UNITED STATES OF AMERICA
NUCLEAR REGULATORY COMMISSION

In the Matter of PACIFIC GAS AND ELECTRIC COMPANY) Docket No. 50-275) Facility Operating License) No. DPR-80
Diablo Canyon Power Plant Units 1 and 2) Docket No. 50-323) Facility Operating License) No. DPR-82

License Amendment Request
No. 98-03

REVISION OF TECHNICAL SPECIFICATION BASES 3/4.6.2.1 "CONTAINMENT SPRAY SYSTEM"

Figure 1

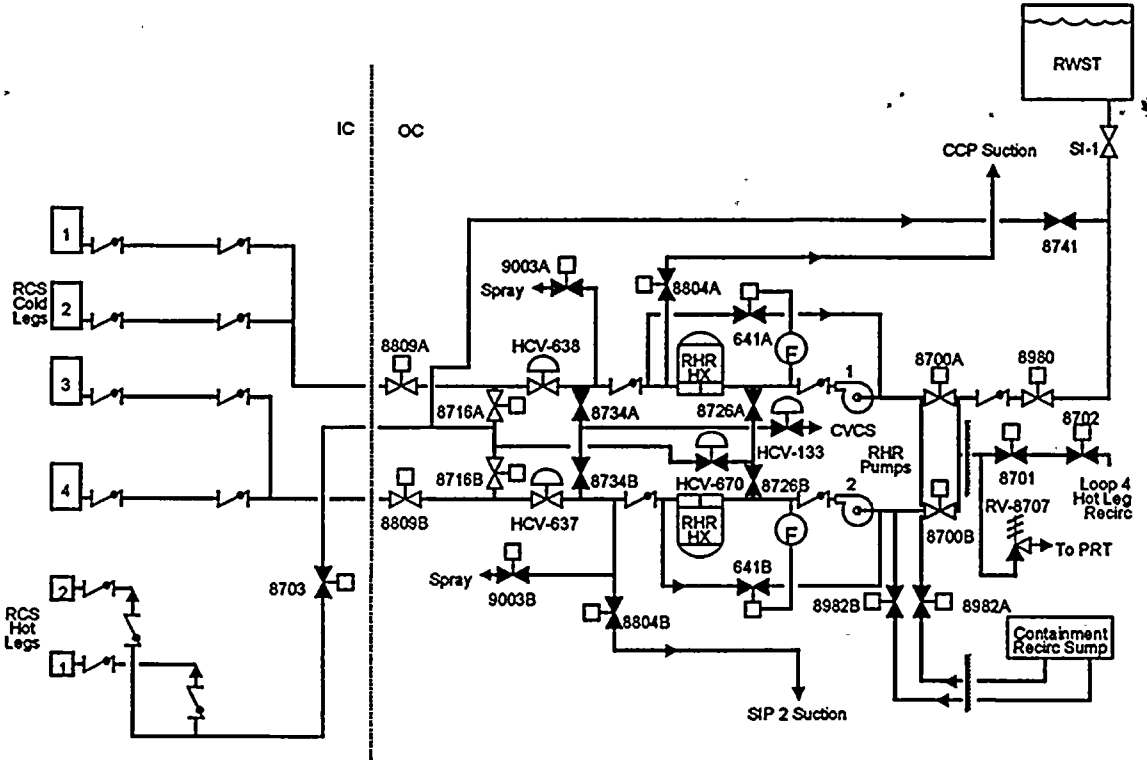
This license amendment request (LAR) proposes to change the Bases for Technical Specification (TS) 3/4.6.2.1, "Containment Spray System," to clarify that containment spray (CS) is not required to be actuated during recirculation, but may be actuated at the discretion of the Technical Support Center (TSC). Additionally, the Bases will be clarified to state that the ability to spray containment using the residual heat removal (RHR) system is demonstrated by opening the RHR Spray Ring Cross Connect Valve 9003A or B. The Bases will also be clarified to state that flow to the spray headers can be established with only one operable RHR pump (RHRP) by closing the cold leg discharge valve 8809A or B.

When the RWST level reaches 4 percent following a LOCA, operators are directed to shut off the CSPs in accordance with EOP E-1.3. At this time, the required safety function of these pumps has been completed. In the design basis containment integrity analysis, this level is reached as early as 1600 seconds (approximately 27 minutes) after the initiation of the LOCA. If two trains of RHR are operating, operators will close valve 8809A or B (refer to figure 1) on the discharge from one RHRP to the cold legs, and open valve 9003A or B on the same RHRP discharge line to the associated CS header. Both RHRPs will continue to feed the CCP and SIP suction, but one RHRP will also provide direct injection to the RCS (via the open valve 8809A or B) while the other RHRP will provide spray flow.

If only one train of RHR is operating, operators are directed not to initiate recirculation spray. A single RHRP cannot feed SIPs, CCPs, the direct injection path through valve 8809A or B to the RCS cold legs, and still have enough discharge pressure to drive water up to the spray rings without shutting off RHR flow to the core. As discussed below, LOCA response EOP E-1.3 is written to provide the maximum flow to the core; however, on direction from the TSC, operators may initiate recirculation spray. Decreasing the flow rate to the core by closing valve 8809A or B (which stops the direct RHR flow to the cold legs) will provide sufficient pressure to drive at least 580 gpm to the spray headers. Even with RHR flow to the RCS cold legs shut off by closing valve 8809A or B, it has been demonstrated that under the worst conditions, the injection flow via the CCPs and SIPs is significantly greater than the minimum required to maintain adequate core cooling.
